MFN 10-314

**NEDO-33312-A, Revision 2, “ESBWR Steam Dryer
Acoustic Load Definition”**

Licensing Topical Report

ESBWR STEAM DRYER ACOUSTIC LOAD DEFINITION

Figure 2.1-1. Comparison of Planned ESBWR and Typical ABWR Vessel Steam Regions

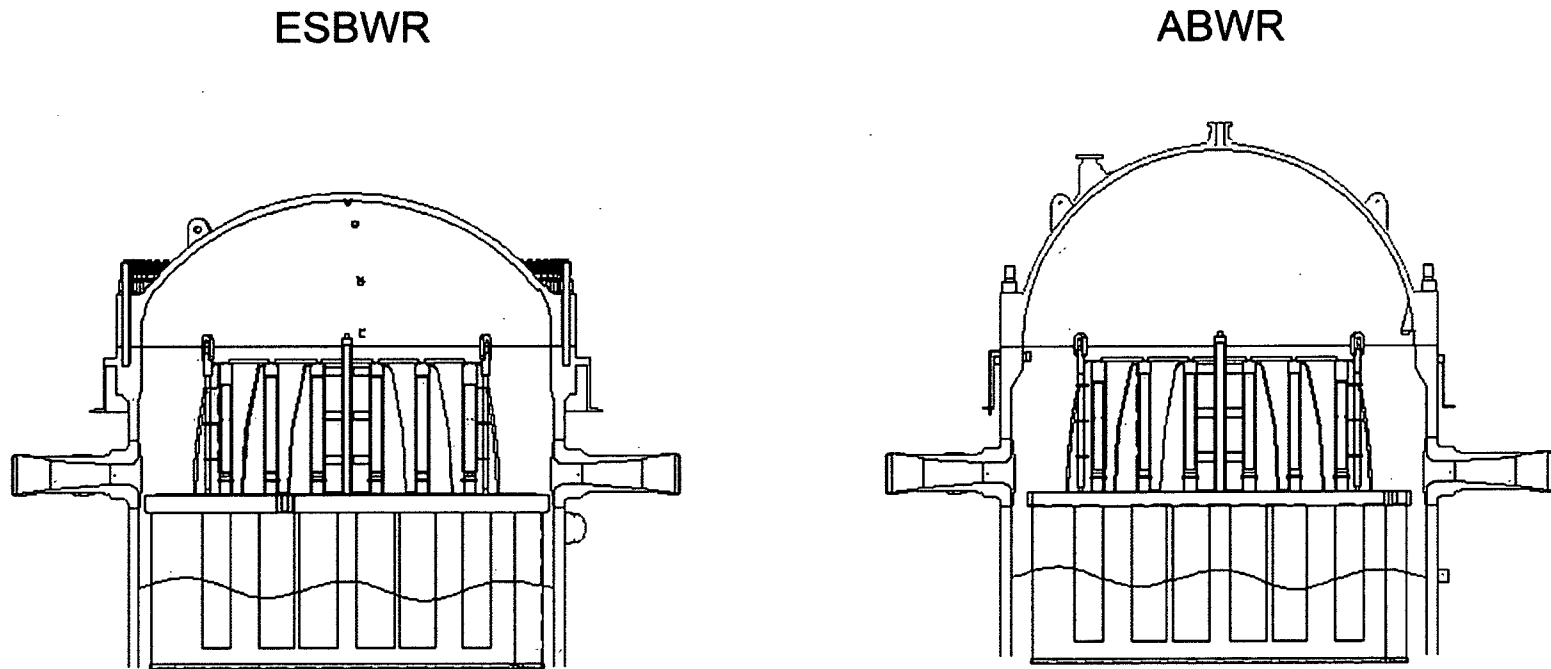
RAI 3.9-205 (Ref. 9), the staff asked the applicant to provide the rationale for the change in the steam dome geometry from hemispherical, as in the ABWRs and BWRs, to torispherical geometry. In its response to RAI 3.9-205 (Ref. 10), the applicant stated that economic reasons drove the design change from hemispherical to torispherical, and reduced reactor building height. The applicant evaluated the steam flow in the new dome geometry, confirming that the changes in steam flow will not affect the dryer loads. However, since the flow velocity in the lower part of the outer hood region will be 15 percent higher than that of the ABWR, in RAI 3.9-206 S01 (Ref. 11) the staff asked the applicant to confirm that any ABWR-based dryer loads will be increased accordingly. The staff therefore closed in favor of RAI 3.9-206 S01, which is discussed below.
